1. Background and Objectives

1.4 Overview of this Survey

Detailed Project Report (DPR) was prepared by PMRCL in 2016 and approved by Bihar State Government in 2018. This JICA survey report was prepared based on DPR discussing with PMRCL and relevant authorities.

Figure 5-21: DANAPUR Station Additional Crossover Layout

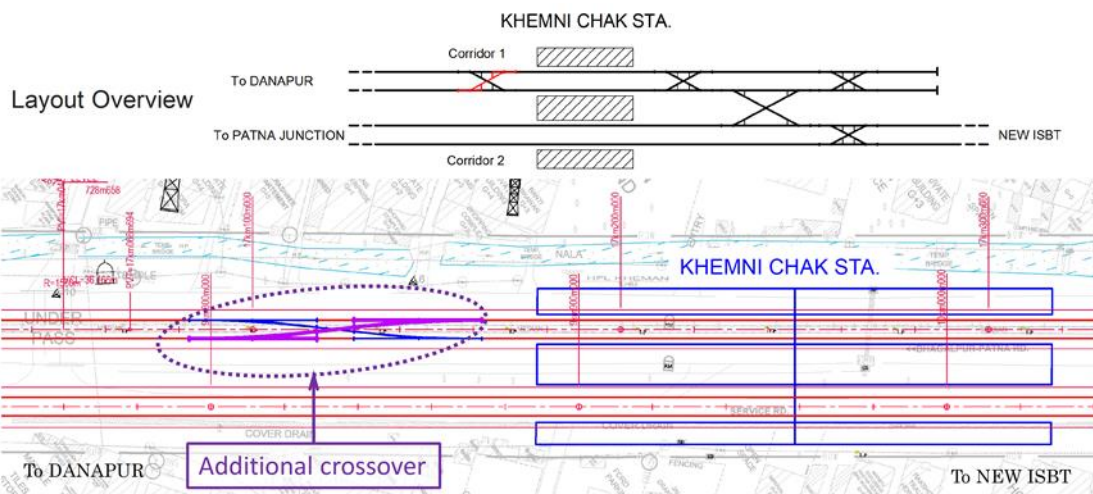
To ensure redundancy of train operations in the event of train breakdowns or other problems, it is proposed to add the crossover at the terminus stations, namely Danapur Station, Khemni Chak Station and New ISBT Station.

Figure 13-4: Proposal for improvement of train route between main workshop and test track

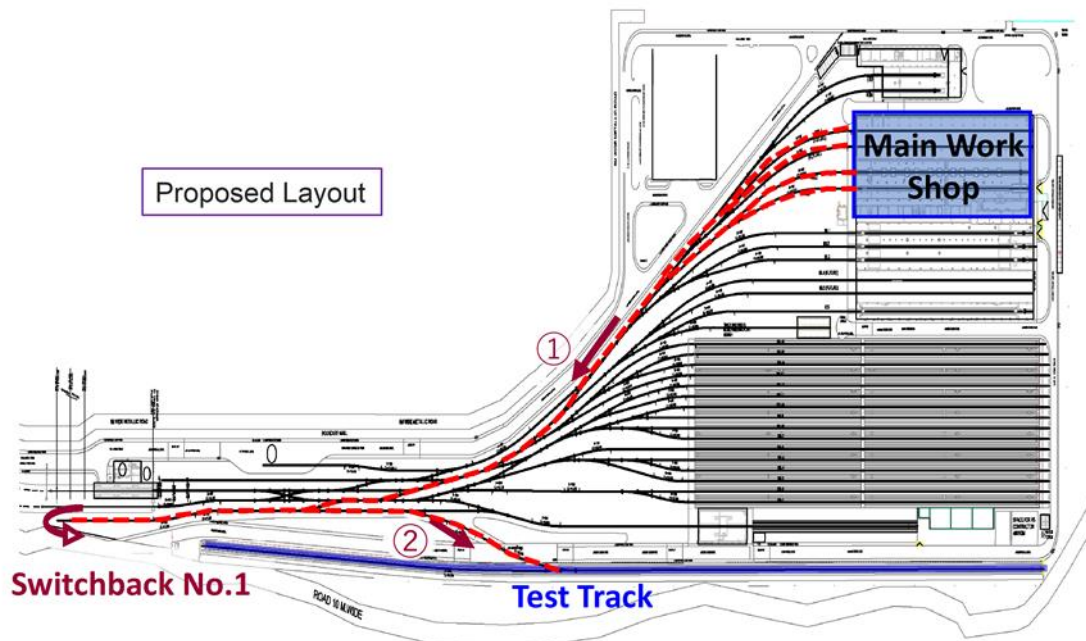
This study reviews the layout of turnouts and proposes the alignment modification that allow trains to move from the depot to the test track in the shortest route without turning back.

See "Figure 13-4: Proposal for improvement of train route between main workshop and test track" for the route of the test track train after the wiring change
